24TH OCTOBER 1891, No. 2800 W., PUBLIC WORKS.

Central Jail at Trichinopoly

Note by the Chief Engineer, Public Works Department, regarding repairs and improvements carried out in the —, recorded.

Central Jail at
Trichinopoly — Reports
on the complaints made
as to the bad workman-
ship in repair and
improvements to the —

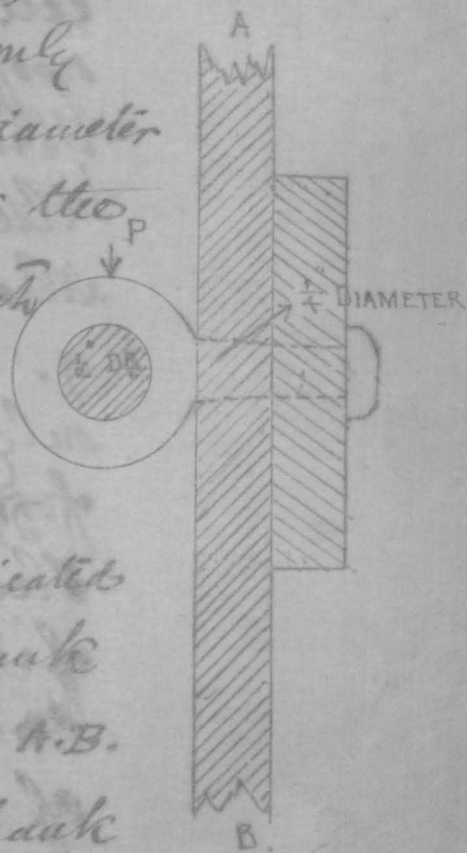
7. In regard to repairing the cell roofs I have instructed the Executive Engineer to put a layer of concrete on the outside from end to end over the crack. This layer of concrete will be from $1\frac{1}{4}$ to $1\frac{1}{2}$ feet wide at bottom according to the straightness of the crack, nine inches thick at the centre and six inches at the sides. I believe this arrangement will stop the leakage.

8. I think that in the case of any cells constructed hereafter, if a masonry roof is provided of the same style as provided in the Trichinopoly Jail, the thickness of the arch at the crown should be at least two feet.

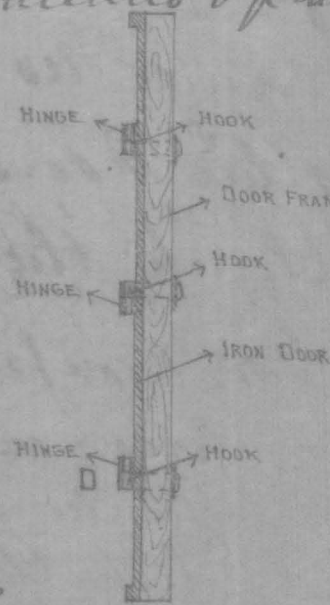
10. Lastly with regards to the iron doors, as regards the locking arrangements, the complaint refers to only seventeen doors. At present the bolt for fastening each of these doors runs through two eyes one on each side of the lock, and then into a hole, protected with an iron plate, in the wooden frame. Each eye has only one shank a quarter of an inch diameter by means of which it is rivetted to the door (really gate) ~~as shown by sketch~~.

What occurred is, that the prisoner put his hand through the bars of door (gate) and hit the eye from above as indicated by the arrow P, and broke the shank at the connection with the plate A.B. A man could not break the shank without using a stone or a hammer, but with a stone or hammer it is very easy to break it. All the doors except the seventeen just referred to, are provided with a "dec" on each side of the lock through which the bolt runs each "dec" being provided

48
provided with two shanks for rivetting to the bar A.B. already mentioned. each shank being 3/8 inch diameter. These "decs" appear strong enough and the superintendent has informed me that he is satisfied with them.

7. The design of the
fastenings for the iron
doors is not a good
one, as the single shank
to the staples does not
give a sufficient hold
on the plate, and the
diameter of a quarter
of an inch, which would
be barely sufficient
if the workmanship ^{were}
perfect allows no
margin of strength for
a defective weld.

which occurred in the particular staple which was broken. That the staple when properly made is strong enough is shown by the fact that Colonel Thompson and myself were unable to break the second staple of this same door though we had the leverage due to the whole length of the bolt to help us.

8. The alteration in design described in the last part of para 10 of the Supt. Engineers' letter will make the doors perfectly safe and is being applied to the seventeen which are on the old design.
